From: Executive Support
Subject: FW: Access Committee item Development Application DA2021/0193 Medical Centre, Chemist and shop top units 17 Condstream St Yamba
Attachments: PROPOSED MEDICAL AND RESIDENTIAL DEVELOPMENT AT 17 COLDSTREAM STREET, YAMBA (1 disabled parking).pdf
Importance: High

BRISBANE RENOVATION GROUP
PROPOSED MEDICAL AND RESIDENTIAL DEVELOPMENT AT
17 COLDSTREAM STREET, YAMBA

Proposed Site Plan
Scale 1:200

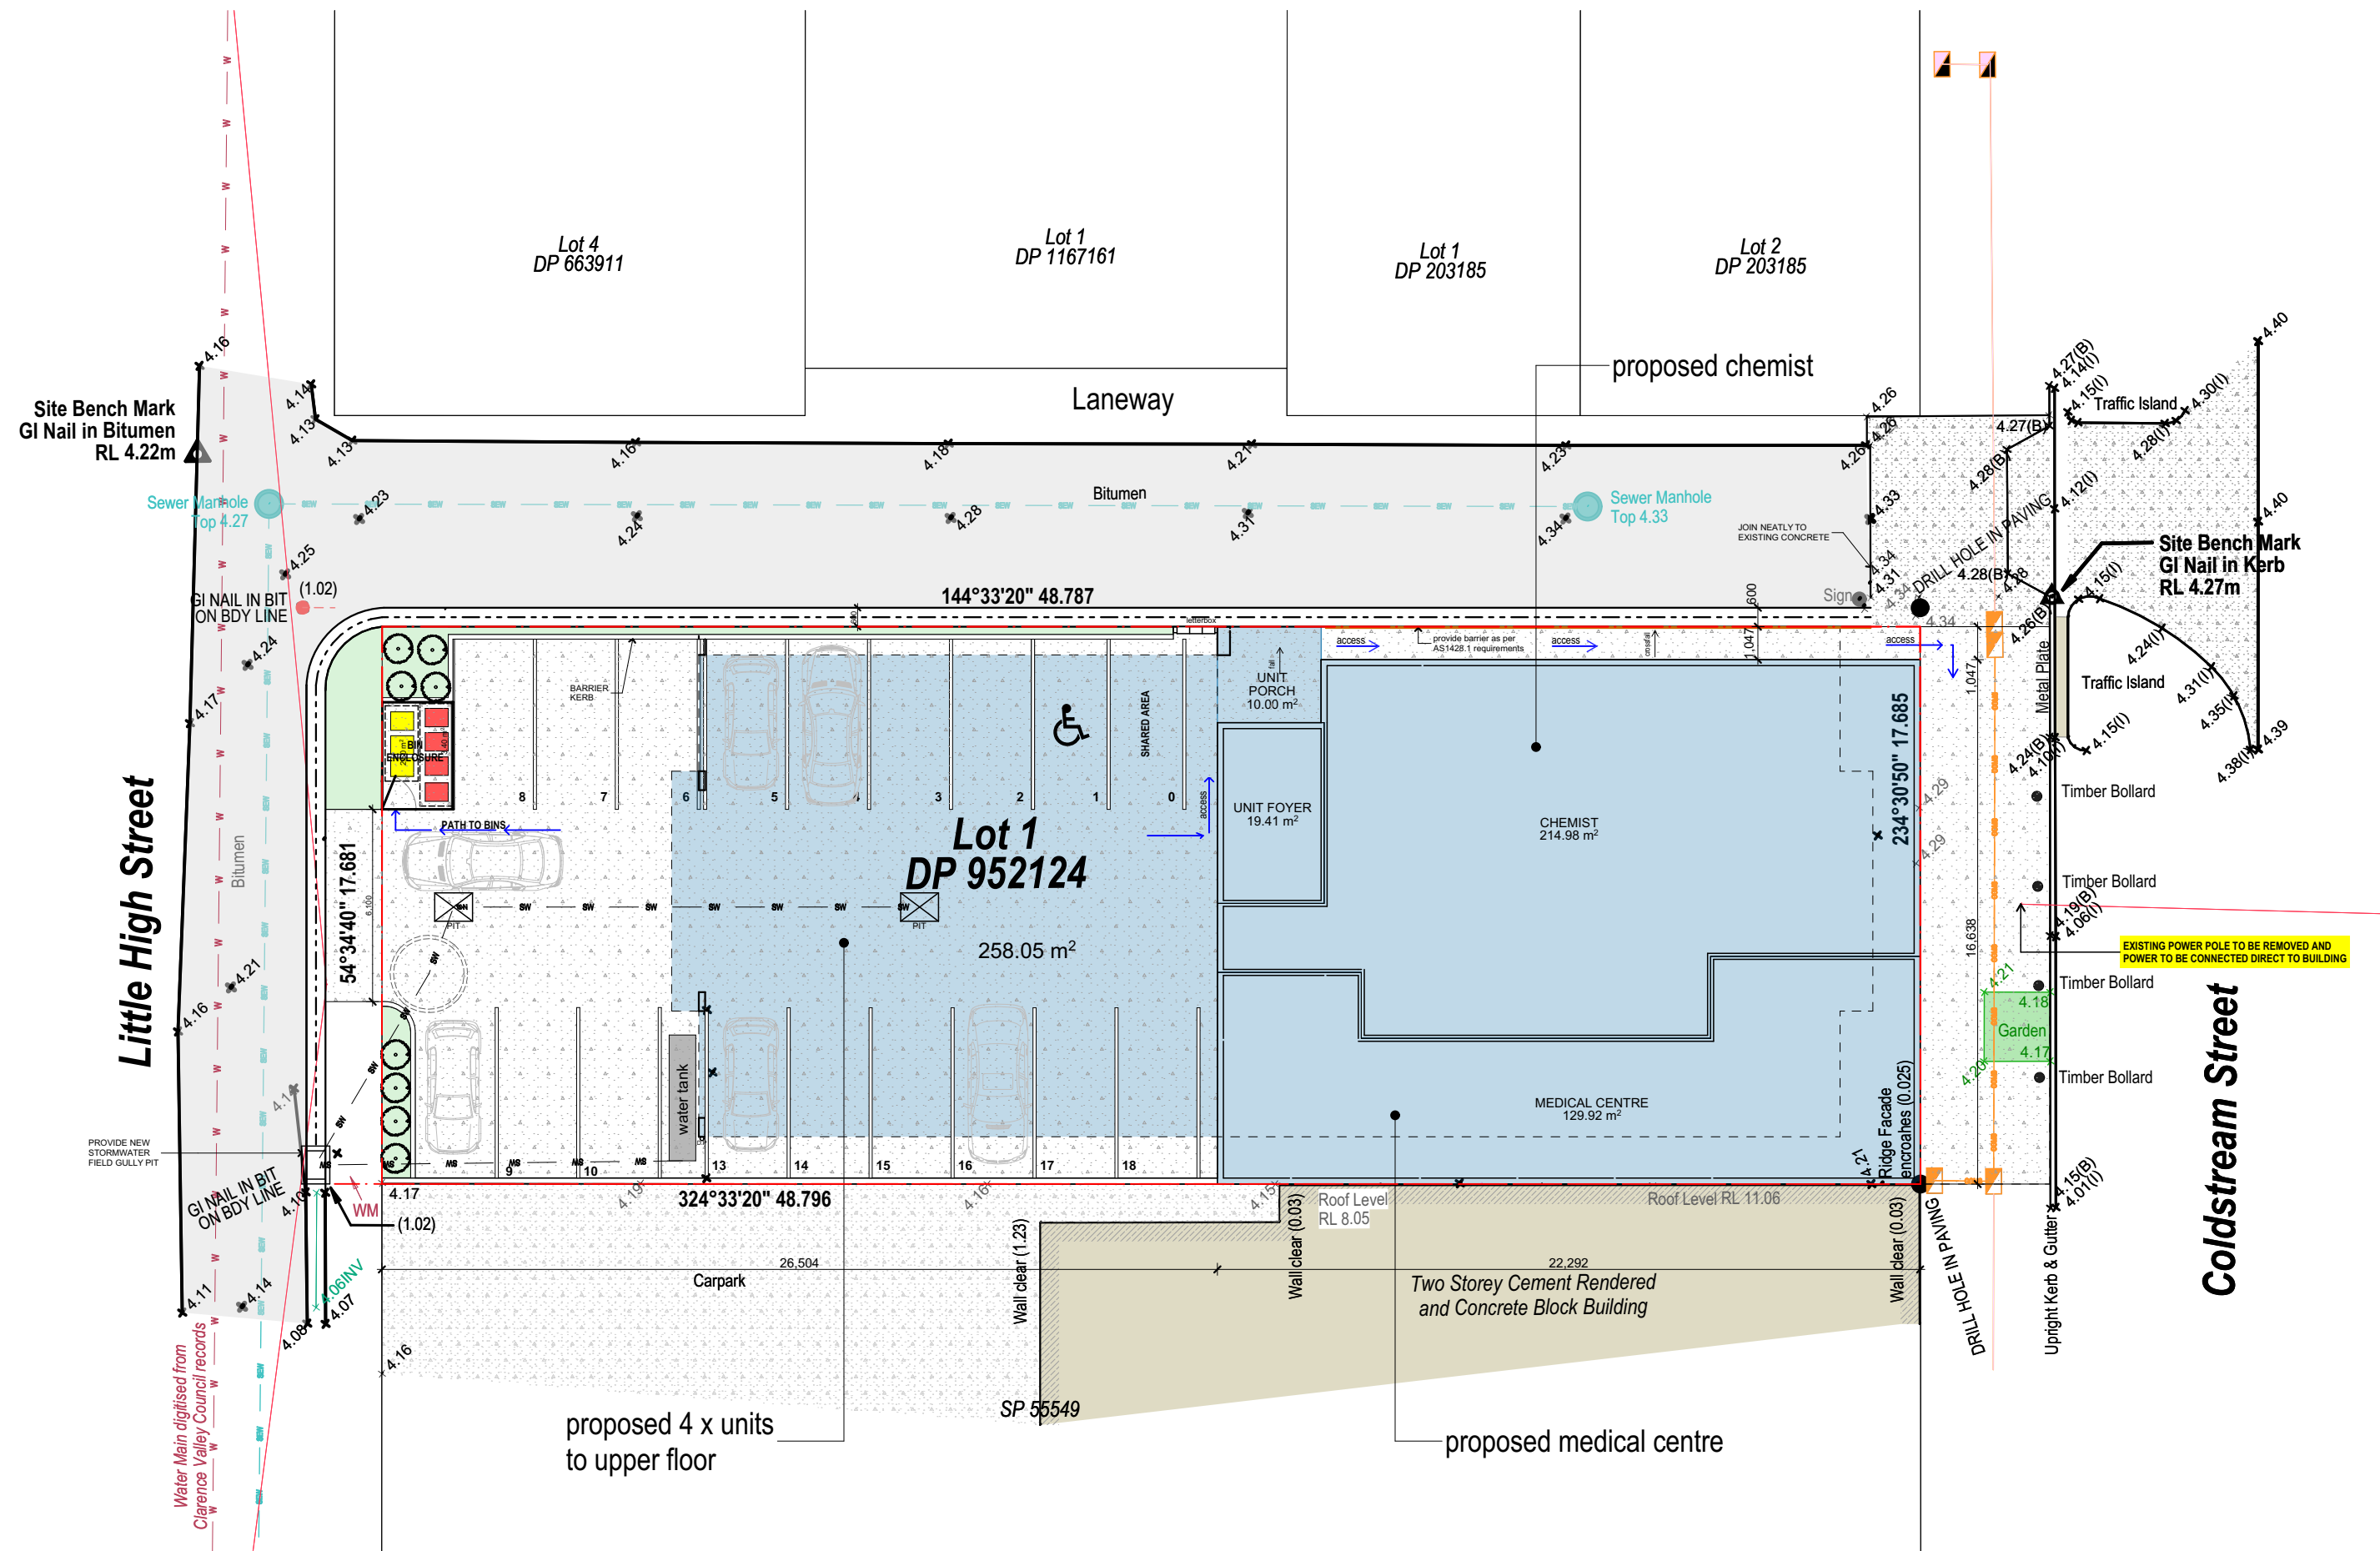
Further to my email yesterday, please see attached the amended proposal plans including 1 accessible space and the inclusion of an accessible pathway through to the front of the building.

Whilst we have modelled an additional accessible parking space, as alluded to yesterday this results in the car using the space closest to the building being unable to reverse out.

1. Additional accessible car parks – whilst the applicant acknowledges the merit and practicality of the committee's request, provision of an additional accessible bay will result in the loss of **minimum** 1 carparking space. We have reviewed all viable options such as relocating the shared area so 2 accessible spaces could use the same shared zone however this will adversely impact manoeuvrability of a car reversing out the PWD space closest to the building.

2. Access to building – as above, the applicant acknowledges the importance of the committee's request and intends to revise the design of the development to facilitate an accessible pathway along the eastern side of the building (wholly contained within the lot and not within the laneway).

Proposed Ground Floor Plan
Scale 1:100

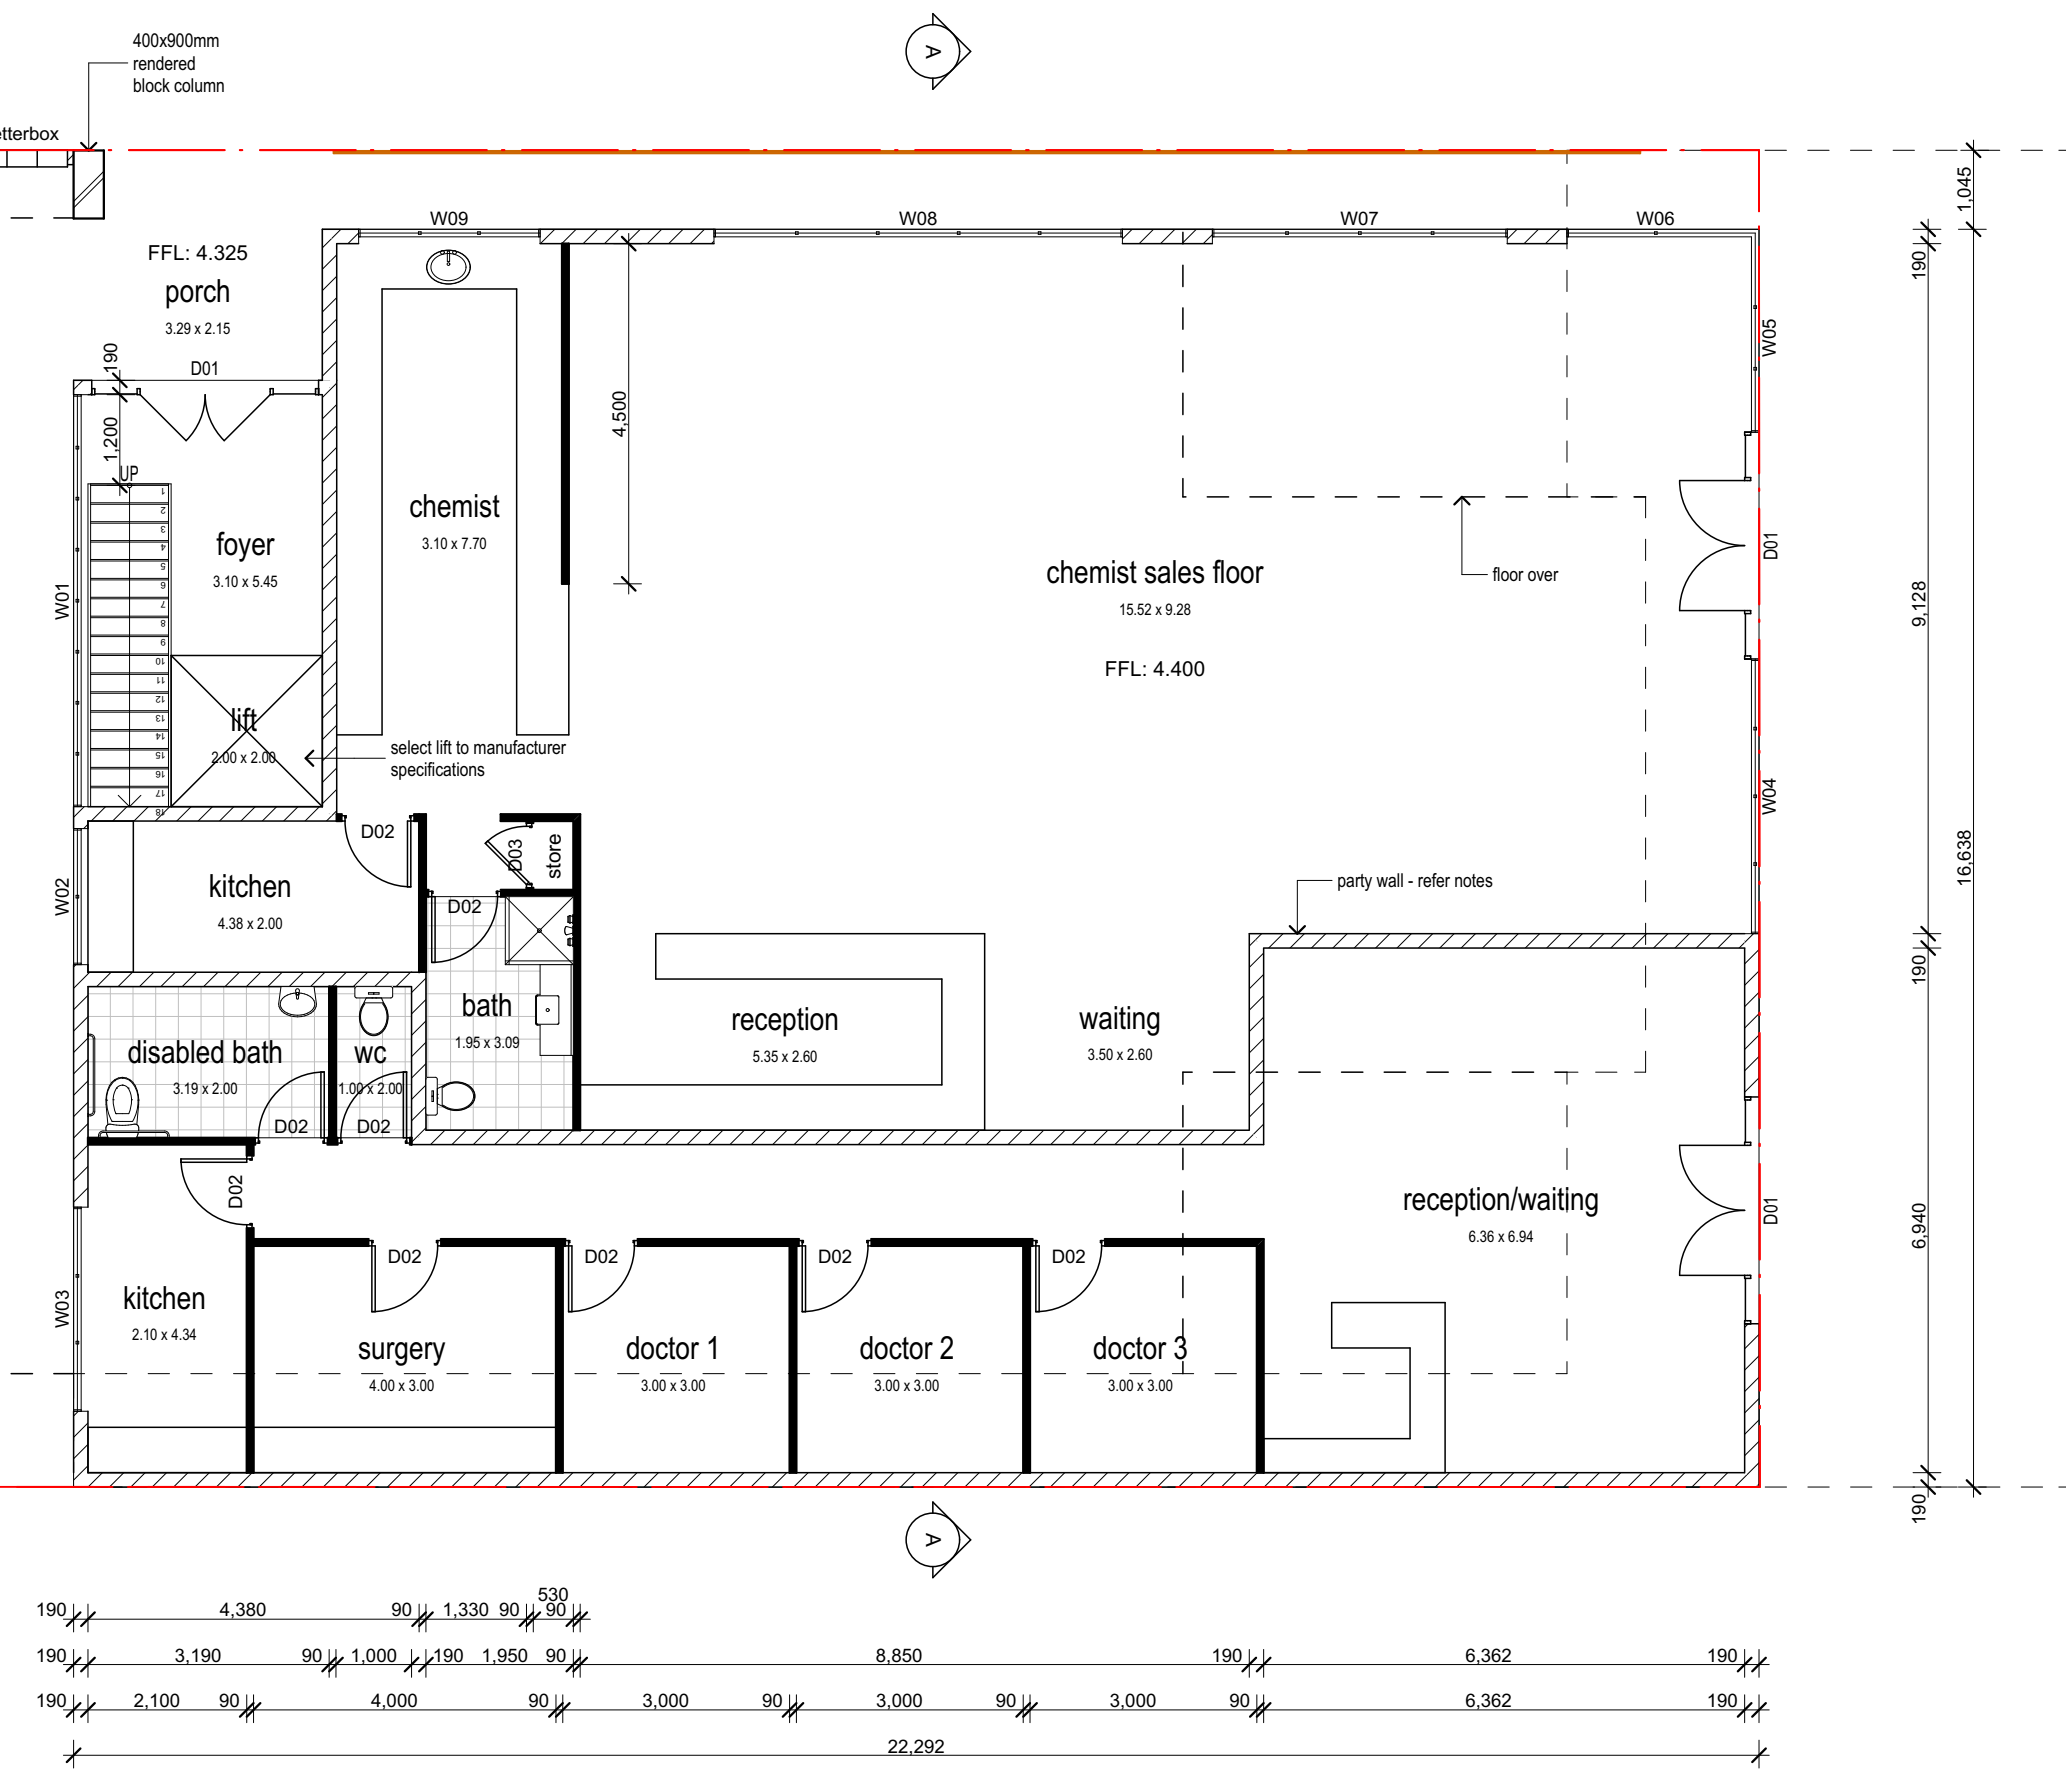
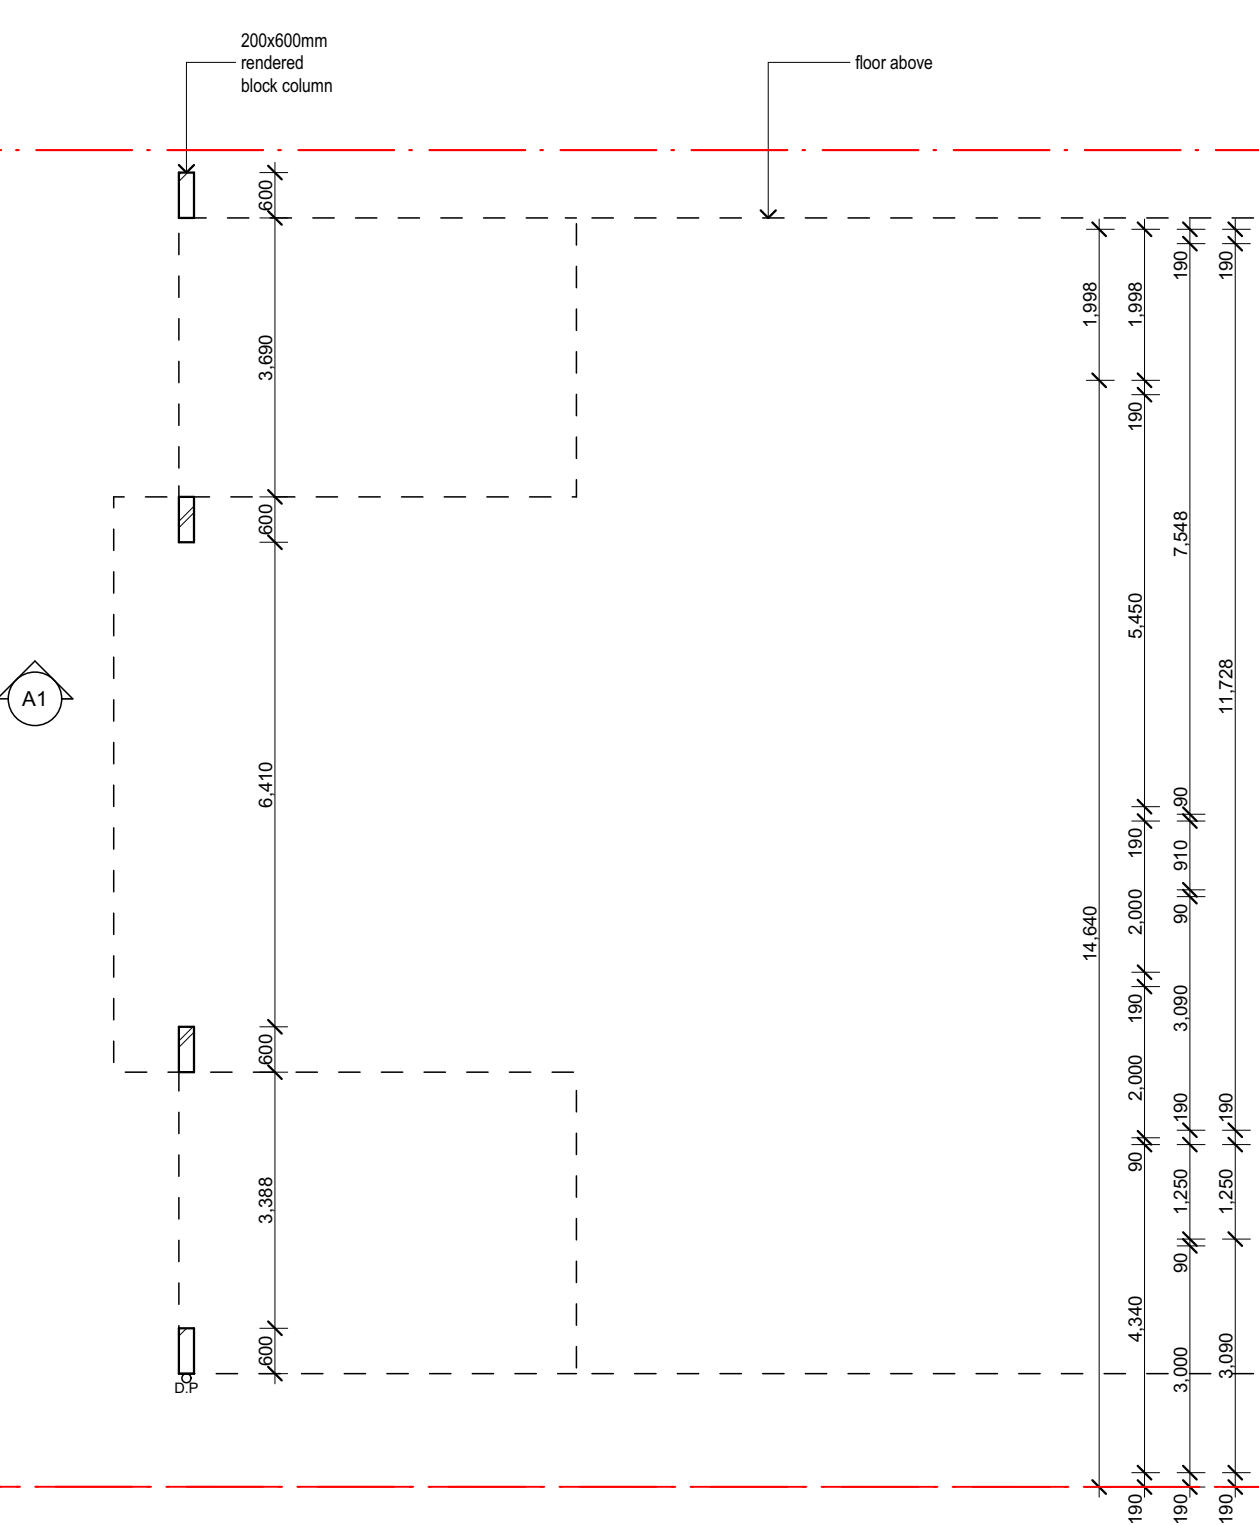
Access directly from the rear of the building is not feasible as this is where all of the back of house operations of the Medical Centre and Pharmacy will occur (i.e. staff room/administration etc). If these areas were to be relocated to the front of the tenancy, this would create a far less desirable outcome with very limited activation or casual surveillance opportunities along the Coldstream Street road frontage.
